Streetscape Design Guide

Consultation Report

Table 5.1: Written comments received and WCC Officer response		
Respondee	Comment	WCC Officer Response
WCC Strategic Planning and Environment Policy Team	<p>Style, layout and structure</p> <p>The style of the document tends to jump from an accessible, easy-to-read style in one section, to being extremely technical in another. It may be worth splitting this into a more general guide, in plain English, supported by a more detailed technical appendix.</p> <p>A clearer and more consistent approach to the document's structure would help the reader. There should be a simple and easy-to-follow layout that moves from outlining the process, roles and responsibilities to outlining expectations, awareness raising, and providing links to further information. These sections are currently mixed together, which is unhelpful.</p> <p>The document would benefit from clearly annotated examples of good and bad design, and greater clarity concerning WCC's expectations.</p> <p>Approach to biodiversity</p> <p>In the context of the document's more detailed technical guidance (e.g. on underground services) the aspirations of mitigation and enhancement measures

The following example, taken from a BDW layout in Worcestershire, demonstrates the design and visual impact that the proposed parking standard would have on residential layouts.

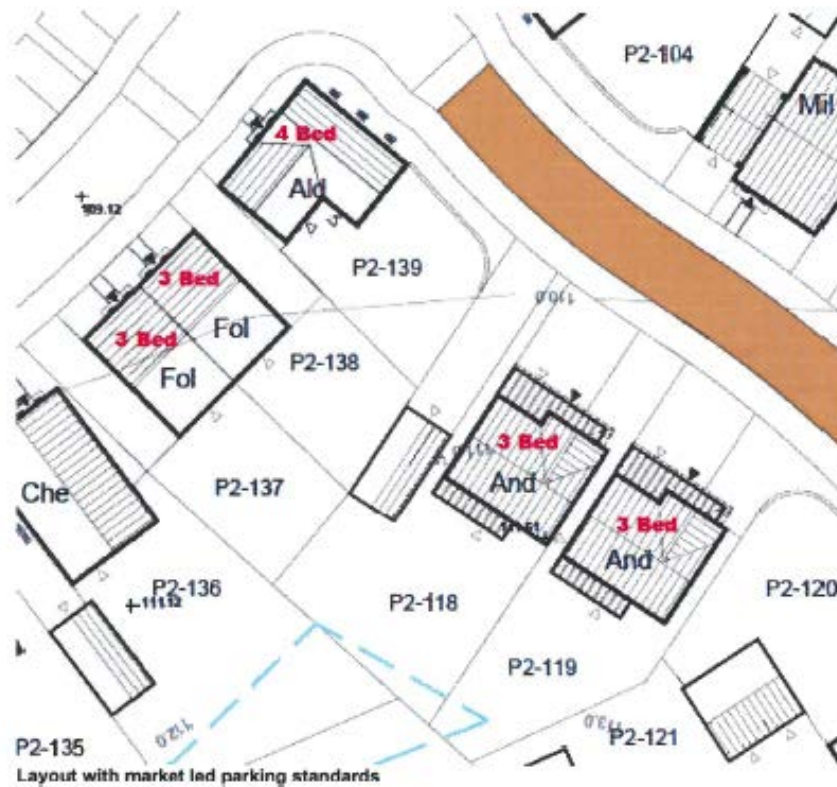
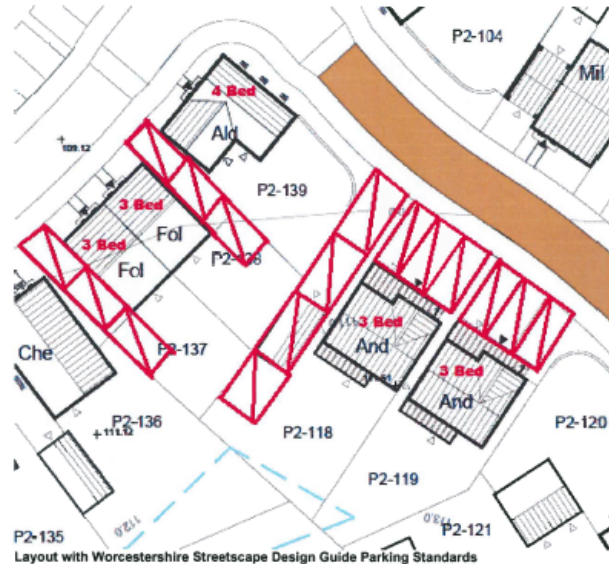
Notwithstanding the principle of setting a minimum parking standard, this requirement would have significant implications for the design and layout of future residential developments. Consequently, we believe that this would make less efficient use of land.

In accordance with the proposed Streetscape Design Guide minimum parking standards, the layout for these dwellings would be as follows;

FOL – the number of spaces would increase from two to three. This would encroach into the private amenity space.

It is probable, from a design perspective, that these parking arrangements won't be satisfactory to a local planning authority. Any amendments to the design and layout of the housing, to accommodate additional parking, would make less efficient use of land and detract from the overall design quality. Although this example only examines a layout at a micro level the implications are much more significant in terms of the effective use of land should all residential developments across Worcestershire be required to apply these minimum-parking standards.
